CONDITIONAL USE PLAN

LAND DEVELOPMENT FOR  
**THE MALVERN SCHOOL**

Re: Malvern School Conditional Use Plan  
Westtown Township  
EBWA No. 4432

### **McCormick Taylor Review Comments**

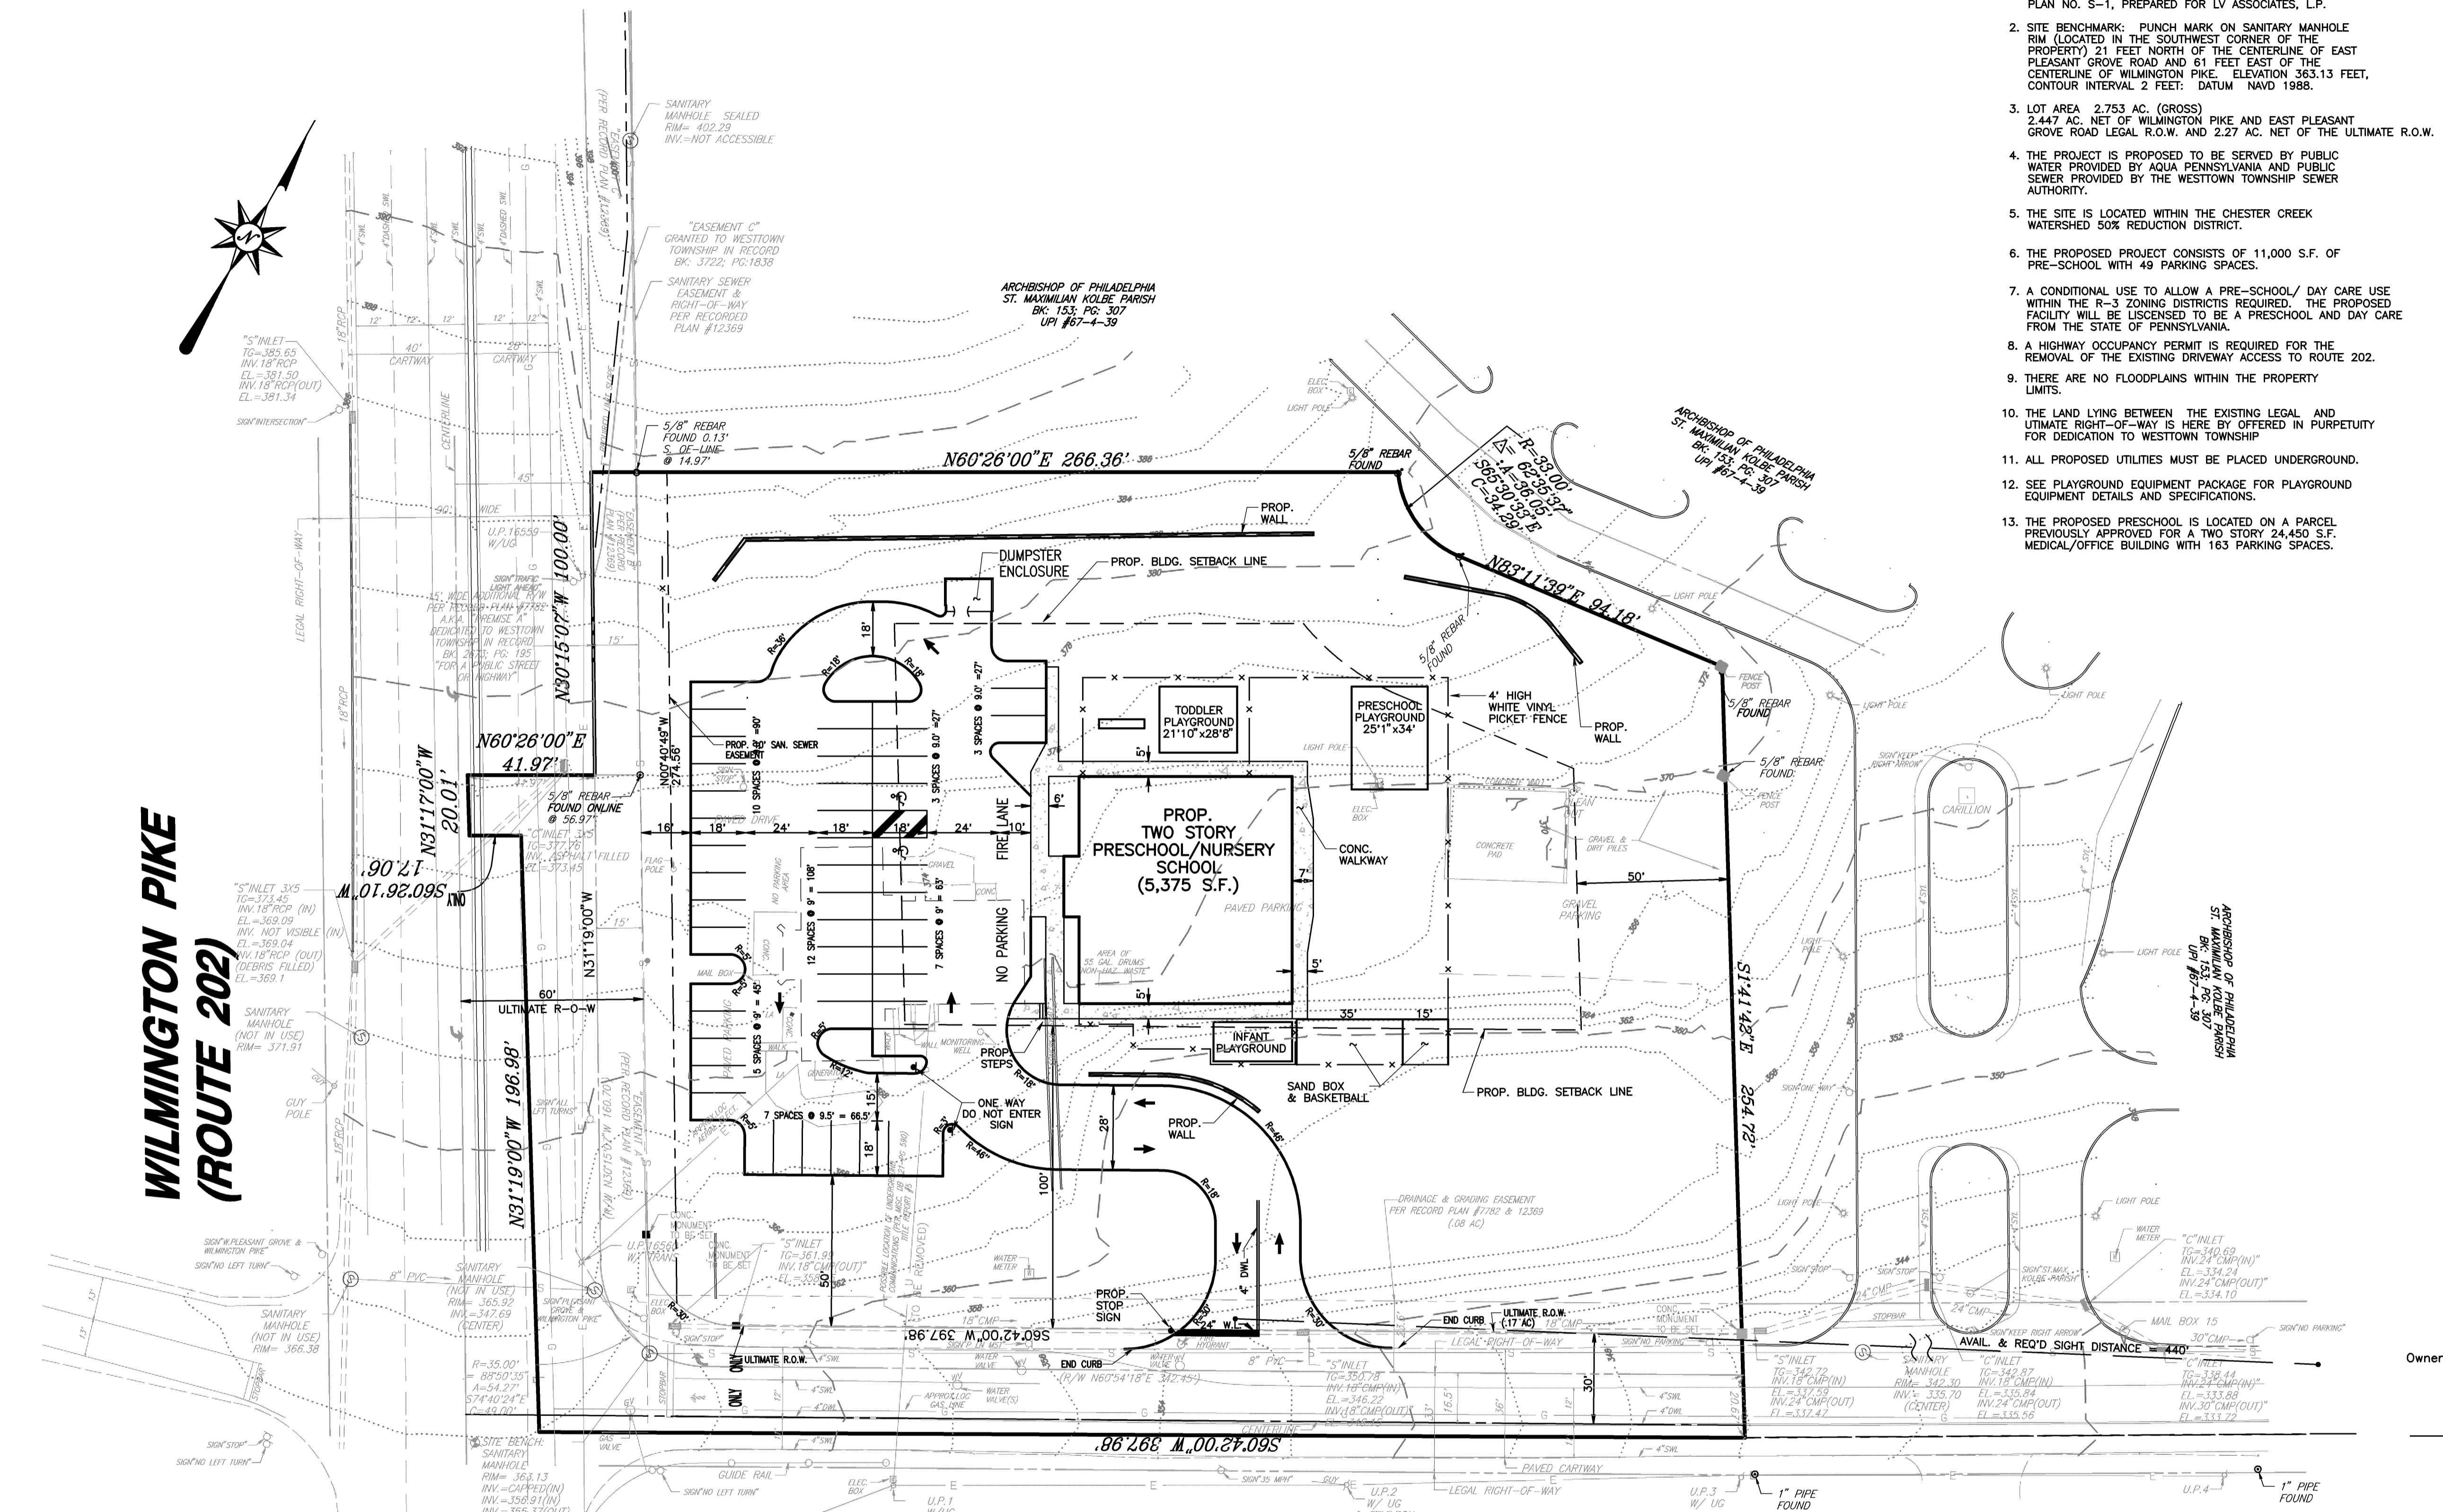
7. The Malvern School gets licensed as both a Preschool and Day Care. See note 7 on sheet 1.
- 8a-c. We have modified the net area calculations to show each deduction as required. The steep slopes on site are not natural steep slopes they were created when the former user constructed their facility. As such they are not regulated.
9. The Day Care building has been shifted away from Pleasant Grove to comply with the 100' setback from the Ultimate ROW. At the staff meeting it was concluded that the St. Maximilian campus is a similar use and that the reduction is acceptable.
10. The zoning data chart has been amended.

17. Legends have been added to the plan sheets.
18. The owner and equitable owner have been added to sheet 1.
19. The property consists of three parcels that will be consolidated with the proposed development. Any additional details, notes or plans that may be required by the solicitor will be prepared and submitted with the Land Development plans.

**CONDITIONAL USE  
EXISTING FEATURES & CONSERVATION PLAN**

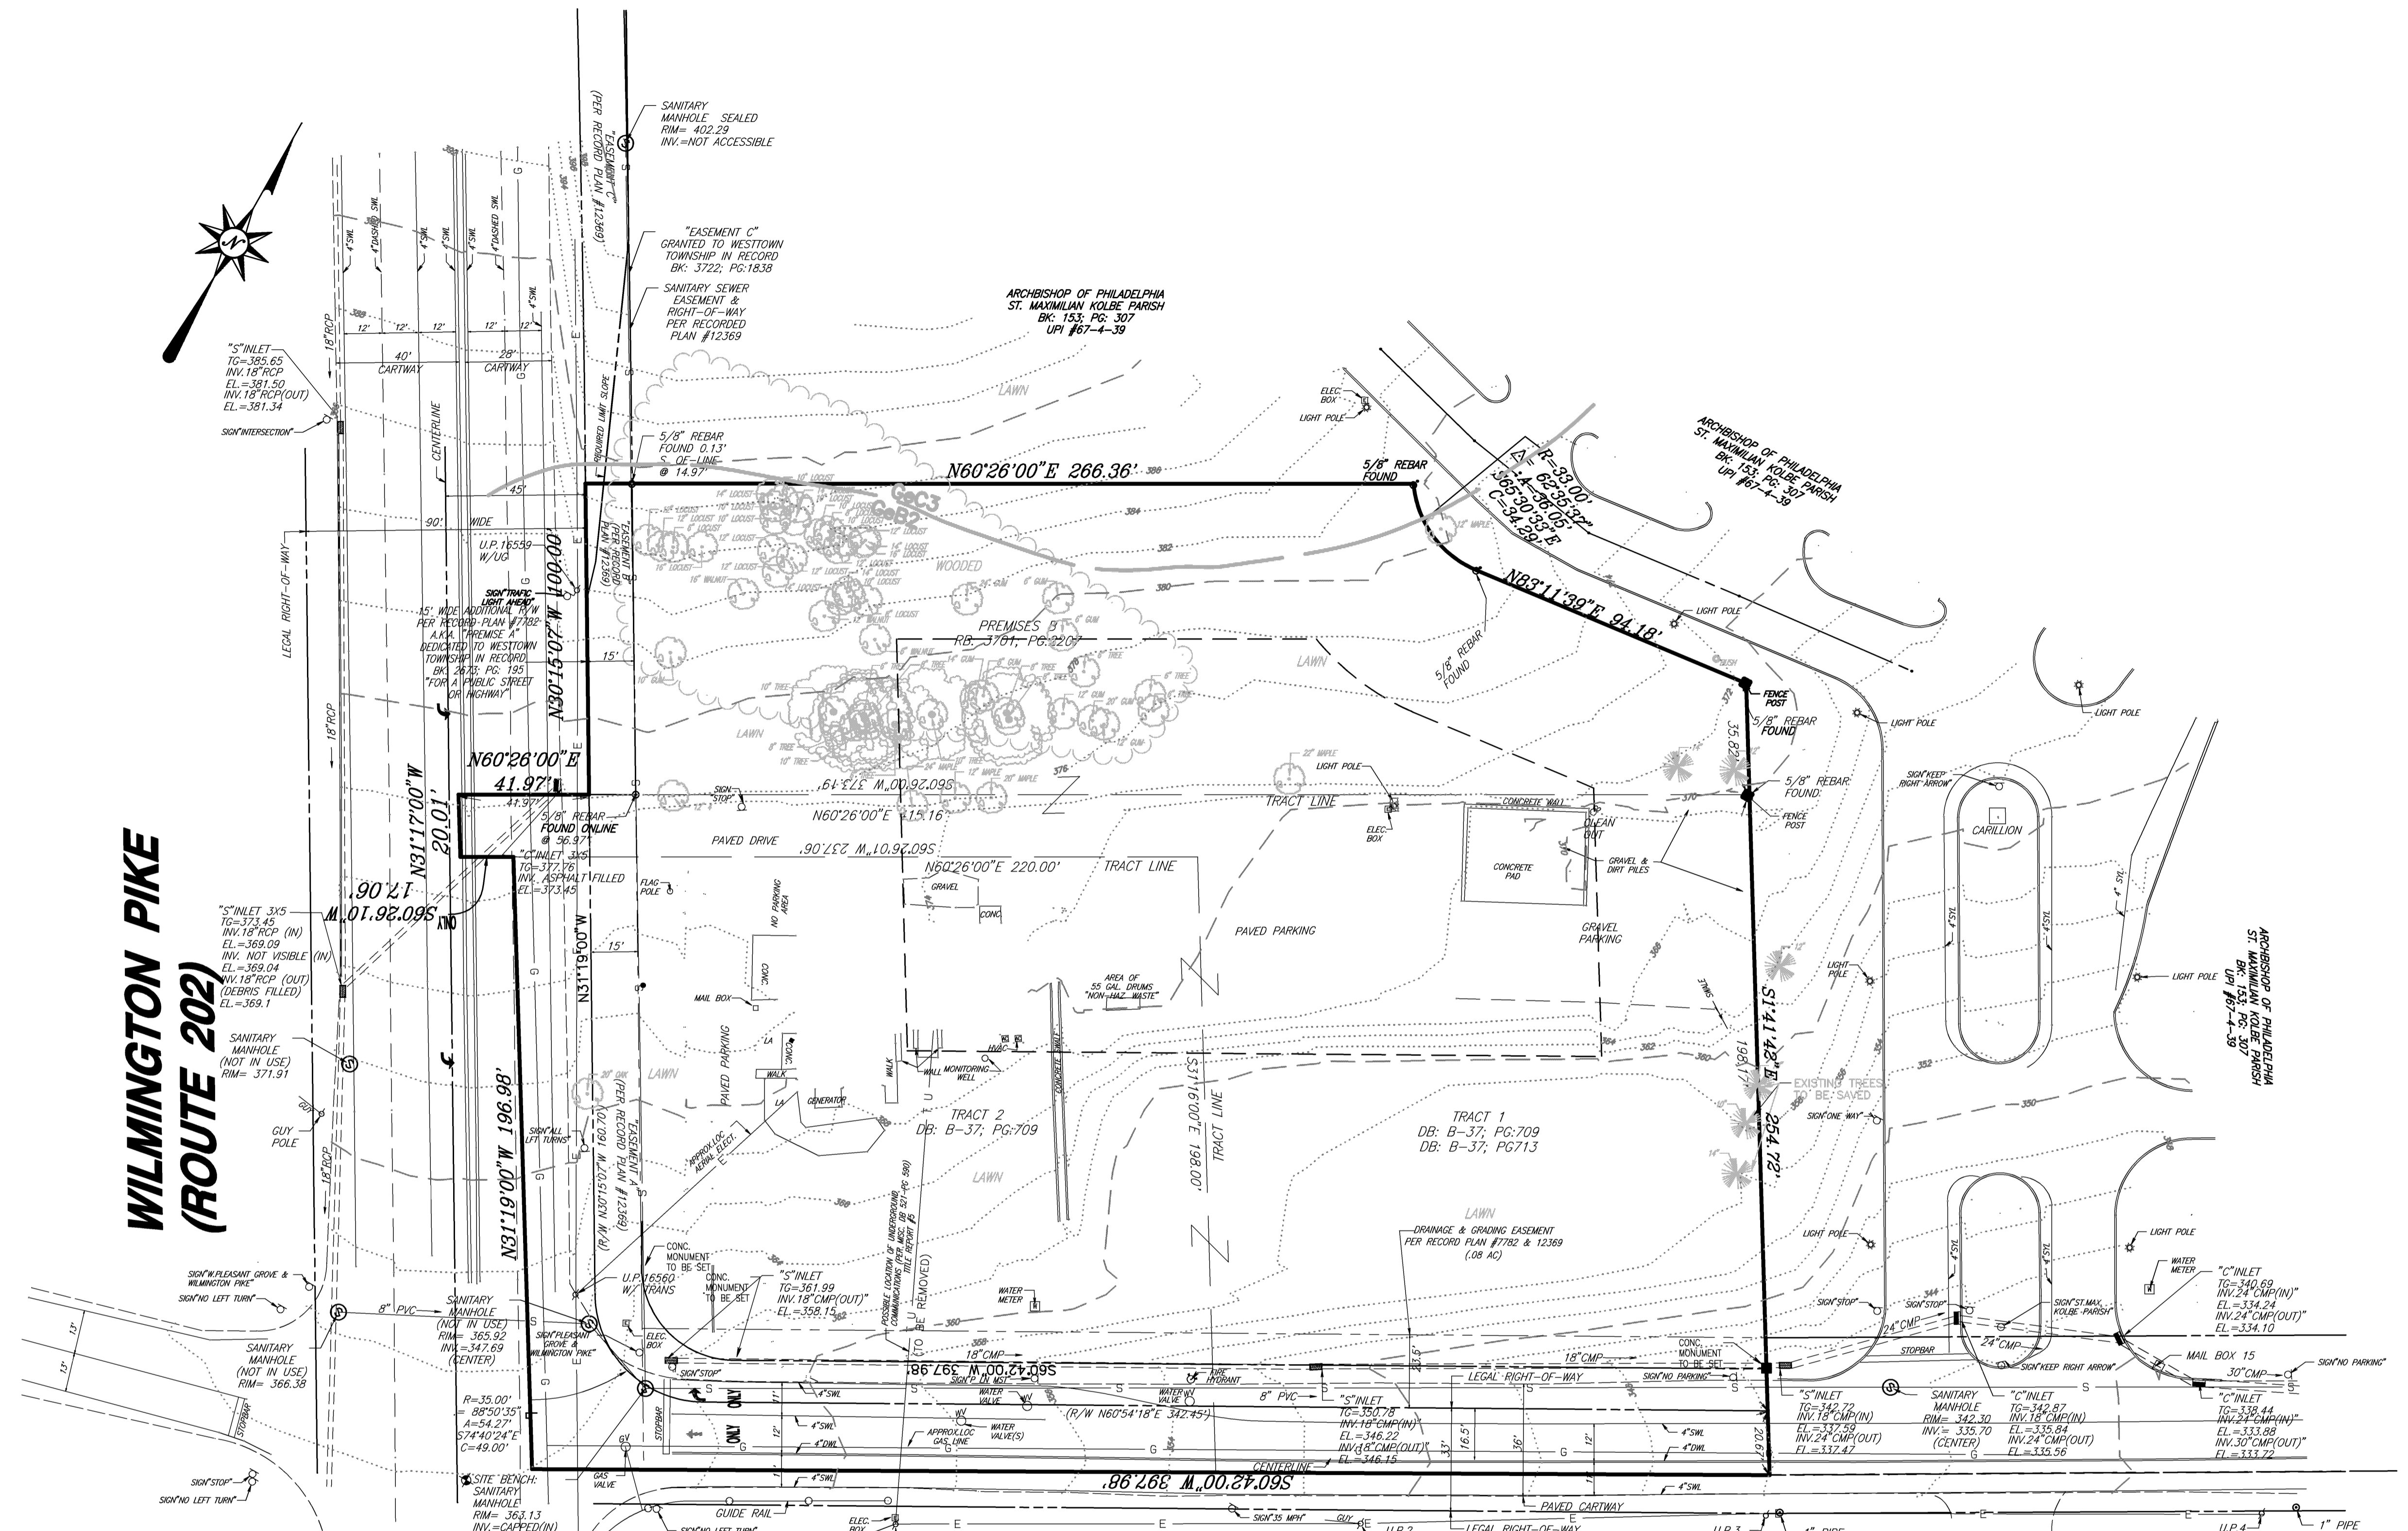
- 1a & b. An Existing Features plan has been added to the plan set.
2. Commentary.
3. Found adequate no revisions necessary.

4. LEED design principles will be discussed and provided by others.
5. The tree removal and existing features/conservation plan can be found on sheet 2.
6. The subject property was previously approved for a 30,000 s.f. Office building that had sewer and water capacity the sewer capacity and water capacity availability has not changed since the prior approval. There is no reason to believe that the current proposal would not have adequate services. Therefore, we believe that we have met this requirement and that during Land Development the specific approvals and details will be worked out. With regard to Emergency services it is in my client's best interest to coordinate with the Emergency services providers and they will do so during the Land Development approval process. Lastly we have added a Fire Truck turning template plan to the plan set.

DUMPSTER ENCLOSURE NOT TO SCALE

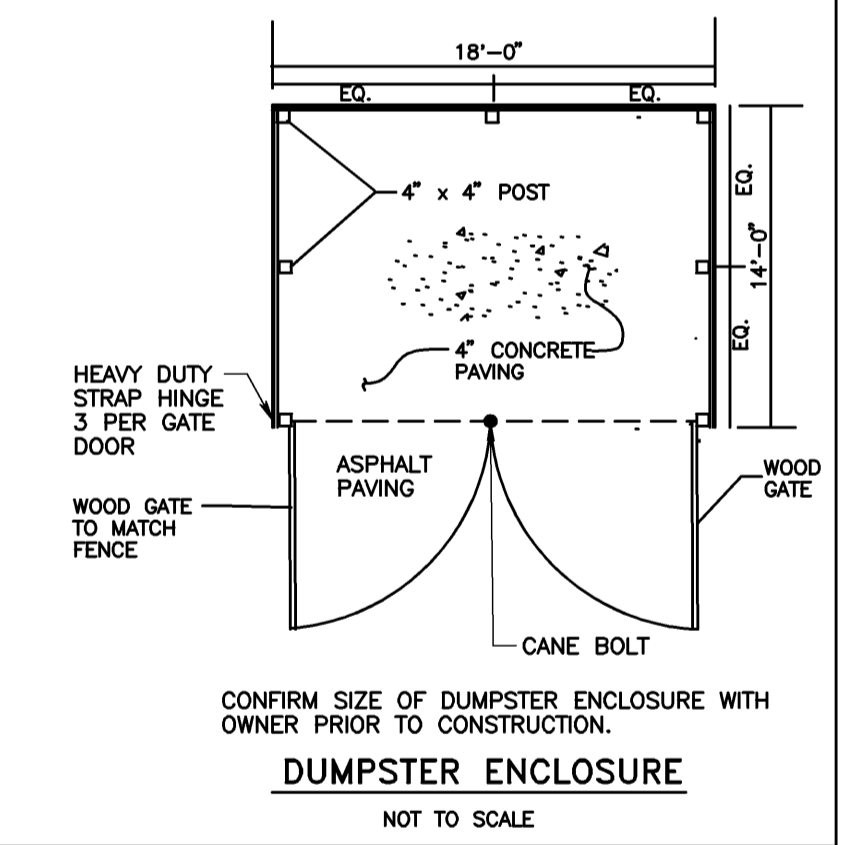
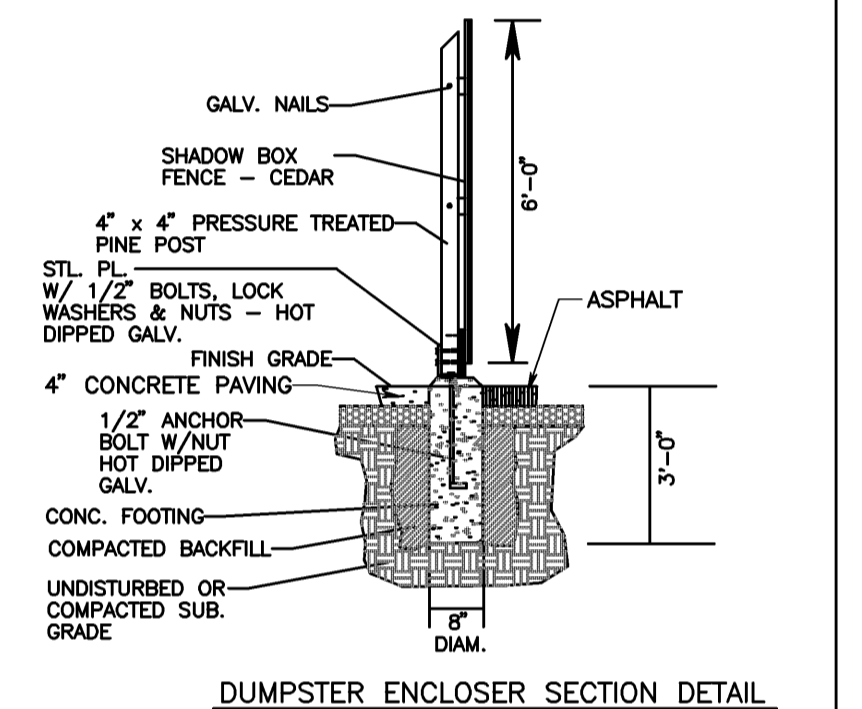
- 11a-b. The dumpster location has been shifted out of the front yard setback and an enclosure has been specified as well as screening. The Facility will comply with any and all trash storage requirements.
- 12ai. We have added the Existing conditions plan that depicts the trees and their sizes.
- 12aii. See response above. The Existing Features plan shows all existing trees to be removed.
- 12aiii. The Landscape plan has been revised to incorporate the additional trees and shrubs.
- 12aiv. The Landscape plan has been modified to incorporate the additional island plantings.
- 12av. The Landscape plan submitted with the land development plans will be sealed by a Licensed Landscape Architect.
